# Access Compliance Report

## Public Rights-of-Way

### (Curb Ramps)

Intersection ID: 15725	Main Street: CLANTON_RD	Cross Street: S_TRYON_ST	Location: SE
ADA ID: B4AB129853B6	Ramp Type: Perp	Initial Pass/Fail: Fail	Overall Compliance: No
Codes/Mitigation Info/Possible Solution		Field Measurements/Component Compliance	
Severity Score: 13.75

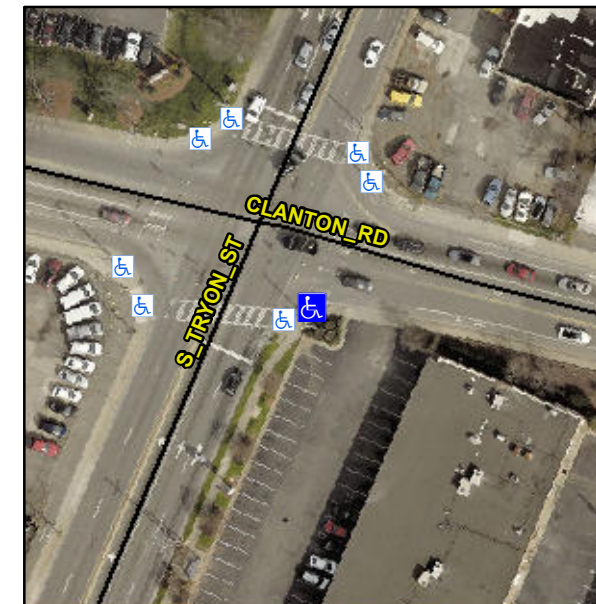
**Not Found, R304.2.2, R304.5.3**

Compliance	Description	Data	Compliance	Description	Data
N/A	Ramp Length (in)	65.0	No	Ramp Slope (%)	9.0
Yes	Ramp Width (in)	48.5	No	Ramp XSlope (%)	2.5
N/A	Flare Type LT	N/A	N/A	Flare Type RT	N/A
N/A	Flare Slope LT (%)	N/A	N/A	Flare Slope RT (%)	N/A
N/A	Flare Traversable LT?	N/A	N/A	Flare Traversable RT?	N/A
N/A	Landing Length (in)	N/A	N/A	DWS Provided?	N/A
N/A	Landing Width (in)	N/A	N/A	DWS Contrast?	N/A
N/A	Landing Slope (%)	N/A	N/A	DWS Length (in)	N/A
N/A	Landing X Slope (%)	N/A	N/A	DWS Full Width?	N/A
N/A	Landing Curb? (Y/N)	N/A	N/A	DWS Offset (in)	N/A
N/A	Shared Landing?	N/A			
N/A	Gutter Ponding?	N/A	N/A	Gutter Slope (%)	N/A
N/A	Gutter Lip Ht (in)	N/A	N/A	Gutter X Slope (%)	N/A
N/A	Painted X Walk1?	Yes	N/A	Painted X Walk2?	N/A
	X Walk 1 Direction	To NE		X Walk 2 Direction	N/A
N/A	X Walk 1 Width (in)	116.0	N/A	X Walk 2 Width (in)	N/A
	X Walk 1 Slope (%)	1.2		X Walk 2 Slope (%)	N/A
	X Walk 1 X Slope (%)	1.4		X Walk 2 X Slope (%)	N/A

**Remove & Replace Entire Ramp.**
